mercruiser
STERN DRIVES & INBOARDS

service bulletin

No. 89-31

Alpha One - Bravo One and Bravo Two Trim Sender Indexing Marks Misaligned

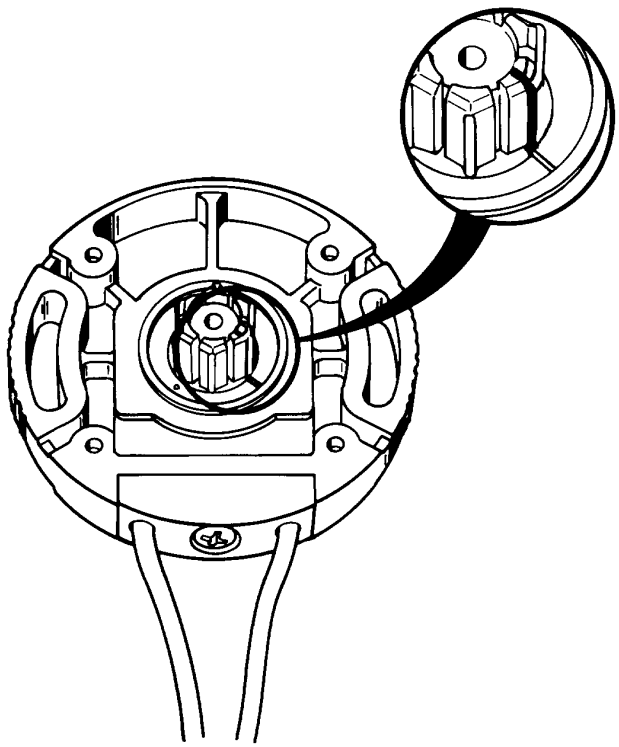
It has been brought to our attention that the indexing marks on the Alpha One and Bravo One and Bravo Two trim position sender may not be aligned properly. Please remove and align indexing marks as shown in the following diagram. When indexing marks are misaligned the trim gauge needle will jump to the top end of the gauge scale when trimming. Units affected are from serial number 0C833540 thru 0C888889.

IMPORTANT: Sender adjustment must be done with stern drive at full down "IN" position. DO NOT adjust sender with stern drive at maximum trim position because sender may be damaged or give incorrect gauge readings.
